BID PACKAGE 01 – ADDENDUM 01

Date: November 22, 2019

Re: Wilma P Mankiller Health Center Expansion

From: James R Childers Architect, Inc.
45 South 4th Street
Fort Smith, Arkansas 72901

SHEET NUMBER:
 S0.03

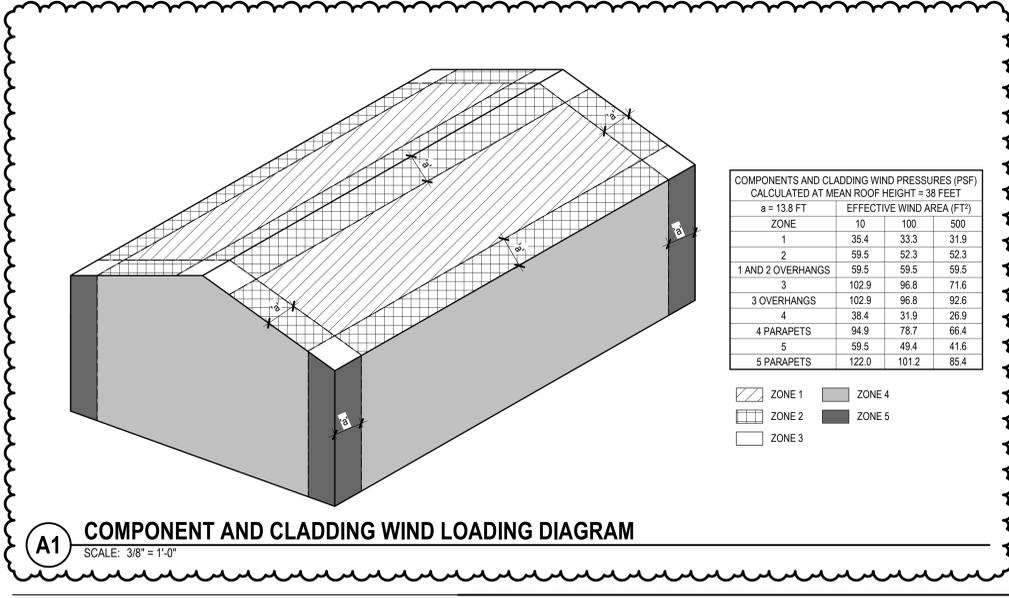
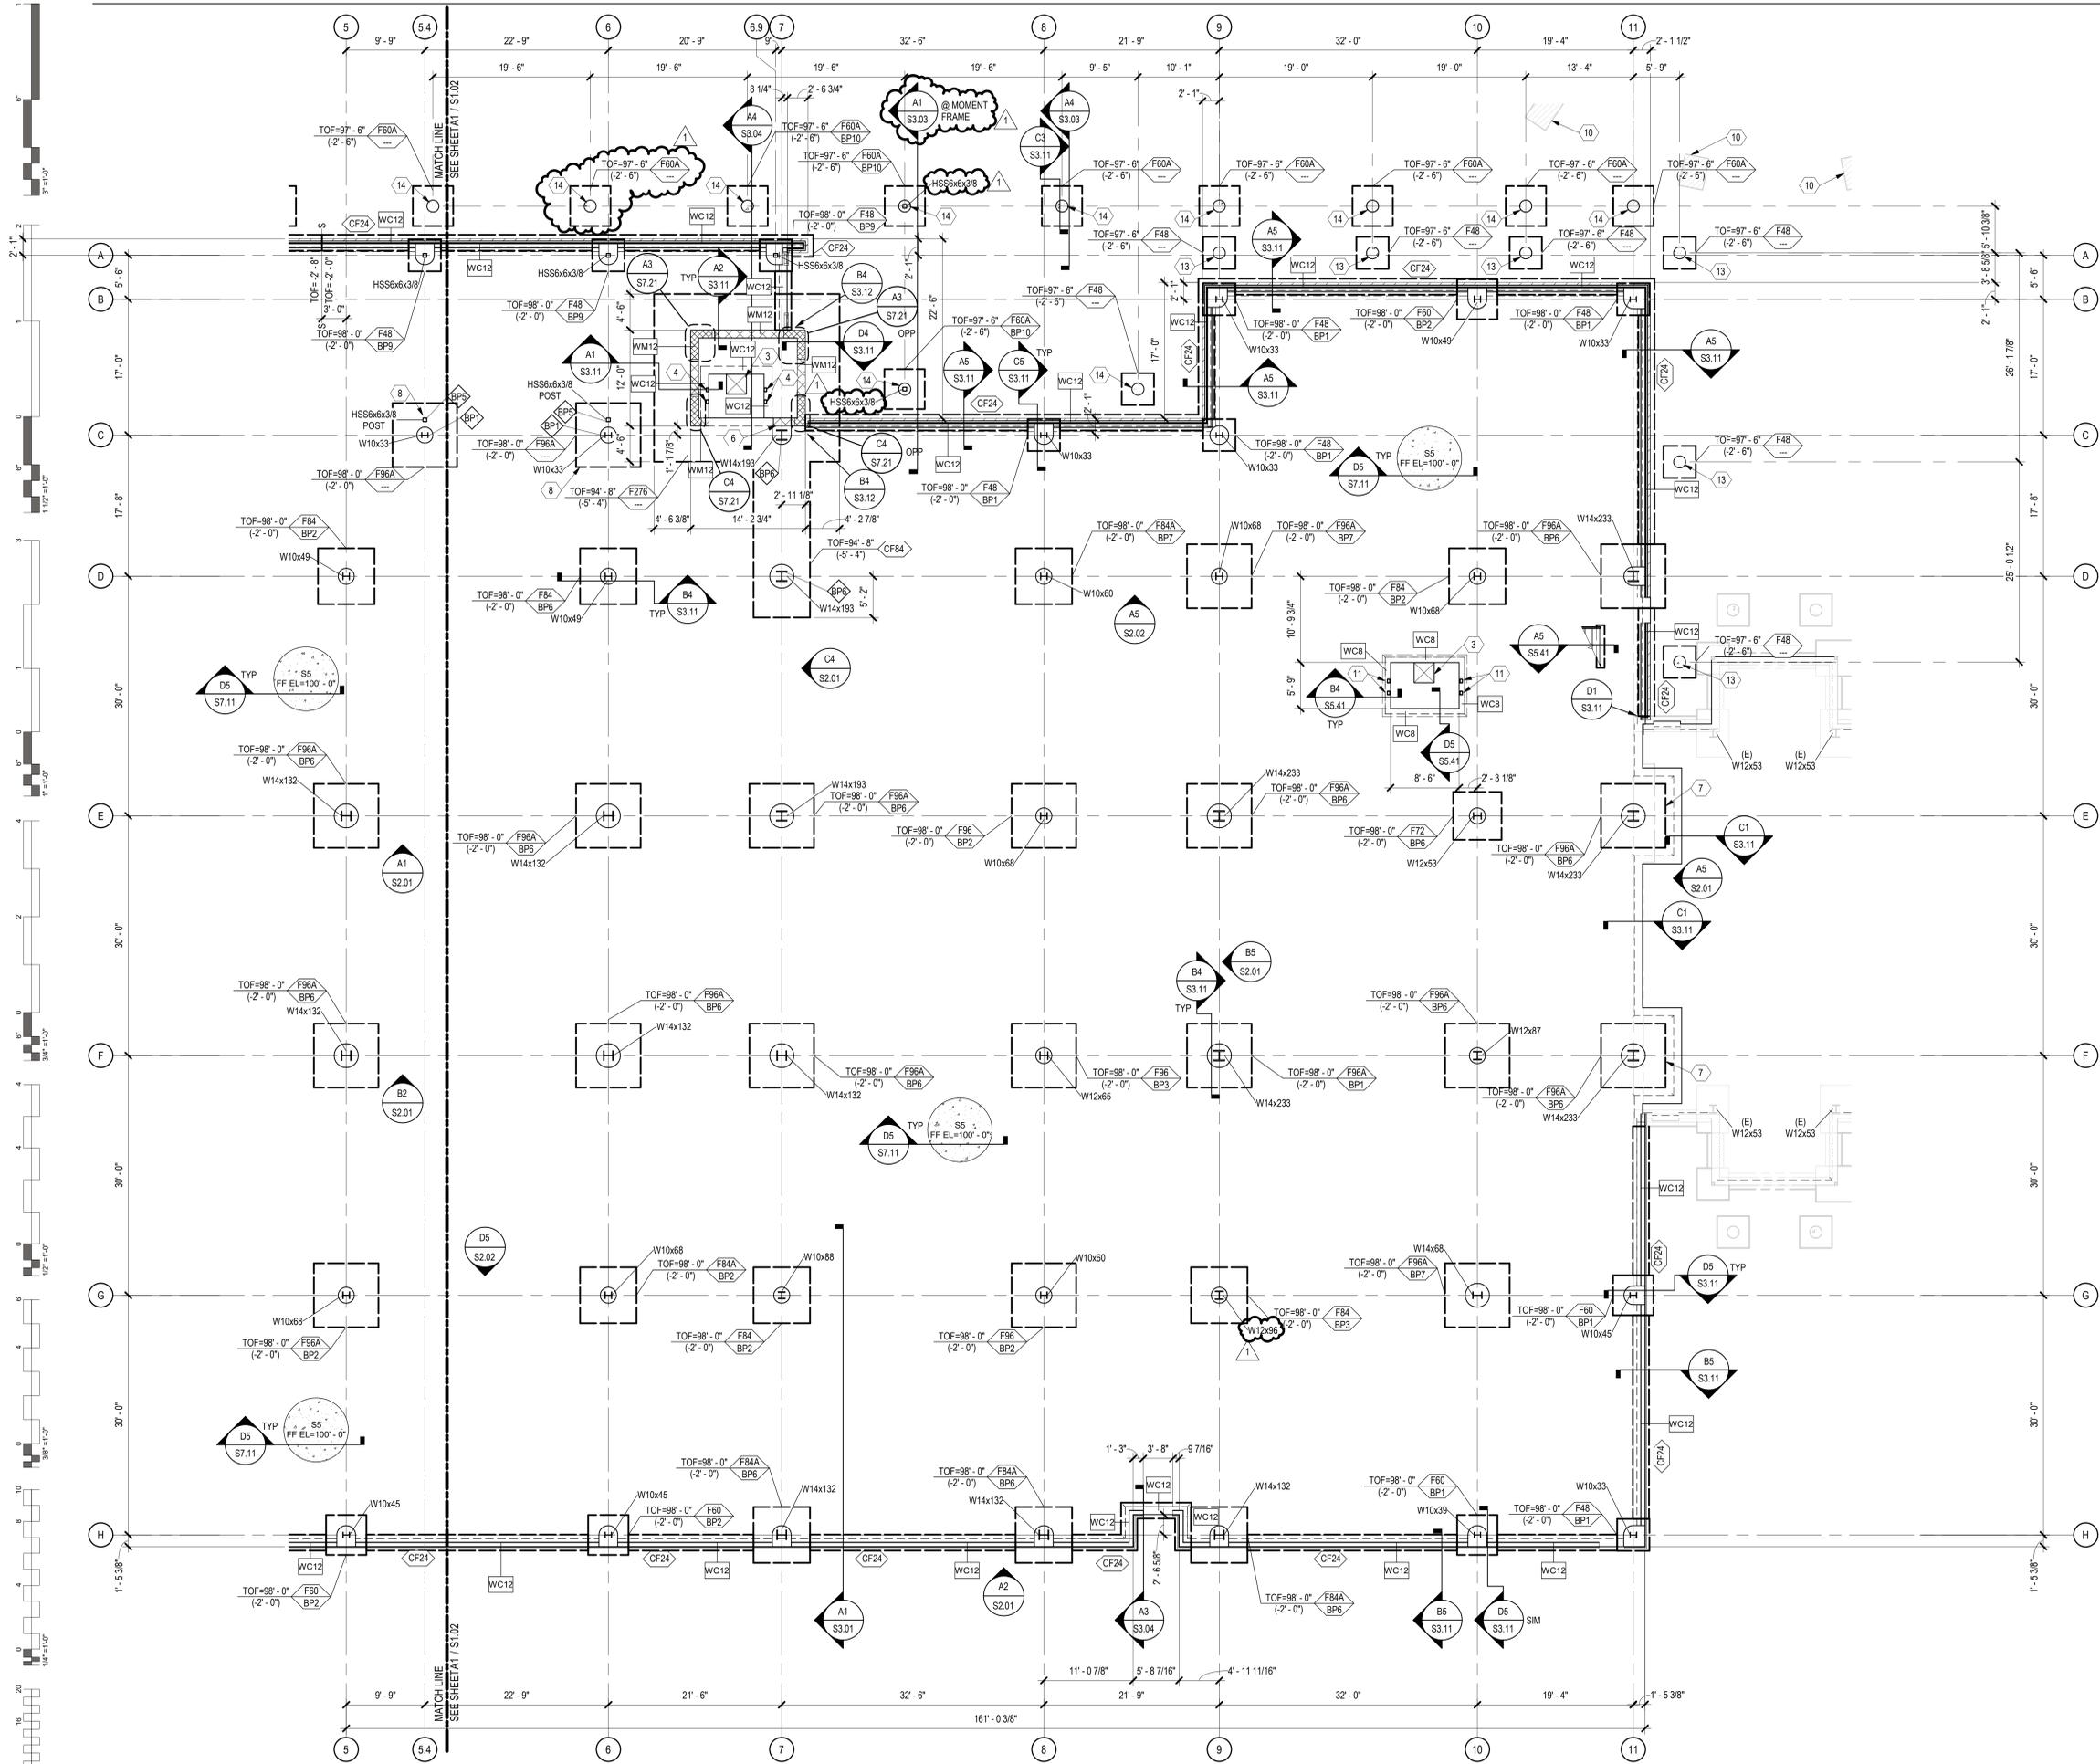
<u>Sheet</u>	<u>Description</u>
S0.02	Revised floor loading information.
S0.03	Revised wind loading diagram.
S1.01	Sheet keynotes 6, 13, and 14 revised.
S1.01	Column size at Grid G/9 revised.
S1.01	Sections added at canopy near Grid A/7.
S1.01	Column and spread footing sizes updated at canopy near Grid A/7.
S1.02	Canopy footings and column sizes revised near Grid A/4.6.
S1.11	Column size at Grid G/9 revised.
S1.11	Beam along Grid 10, between Grids G and F updated.
S1.11	Beams between Grids 9 and 11, near Grid D updated.
S1.11	Pilaster tags added to masonry shaft wall.
S1.11	Canopy/lobby area top of steel elevations added near Grids A and C.
S1.11	Canopy/lobby area details and sections added near Grids A and C.
S1.11	Canopy/lobby area clarifying dimensions added near Grids A and C.
S1.12	Canopy/lobby area top of steel elevations added near Grids A and C.
S1.12	Canopy/lobby area details and sections added near Grids A and C.

SHEET NUMBER: S1.13

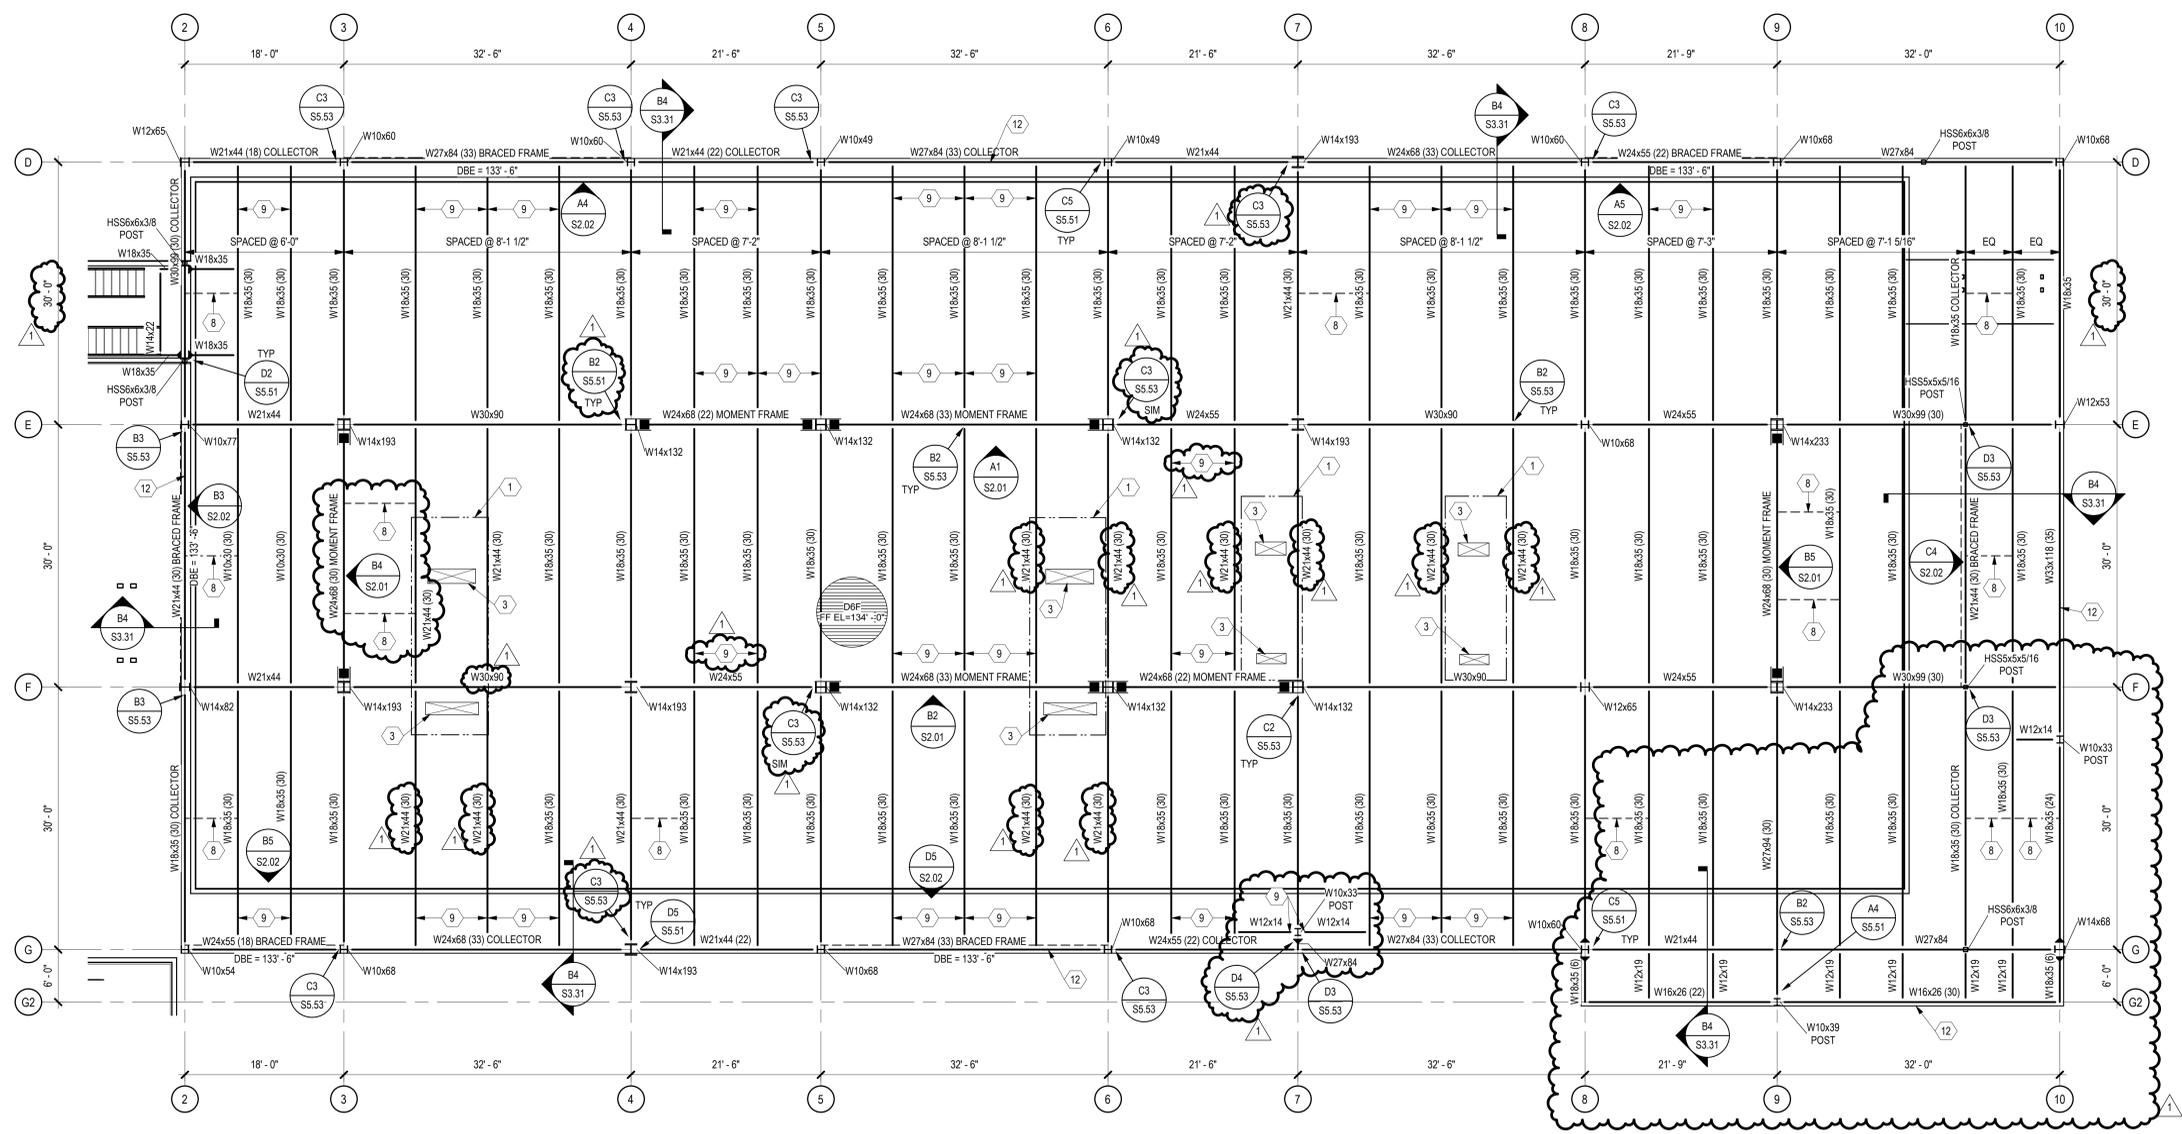
S1.12	Canopy/lobby area clarifying dimensions added near Grids A and C.
S1.12	Operable partition support beam sizes updated near Grid D, between Grids 1 and 2.
S1.12	Detail D3/S5.53 added near Grid H/2.
S1.13	Sheet keynote 12 revised.
S1.13	Snapping point between Grid E and D corrected.
S1.13	Beams/girders supporting rooftop mechanical units revised.
S1.13	Framing between Grid G/8 and F/10 revised.
S1.13	Connection details at Grid G/4 and D/7 revised.
S1.13	Beam removed and bottom flange bracing (keynote 8) added to moment frame beam at Grid F/3.
S1.13	Connection details updated at Grids E/4, E/6, D/7, and F/5.
S1.13	Bottom flange bracing (keynote 9) added to girders along Grid F and E, between Grids 4/5 and 6/7, respectively.
S1.13	Beam/bottom flange bracing added at post near Grid G/7.
S1.21	Clarifying dimensions and sections added around interior and exterior roof perimeter.
S1.21	Location of enlarged framing plan tag D2/S4.01 adjusted.
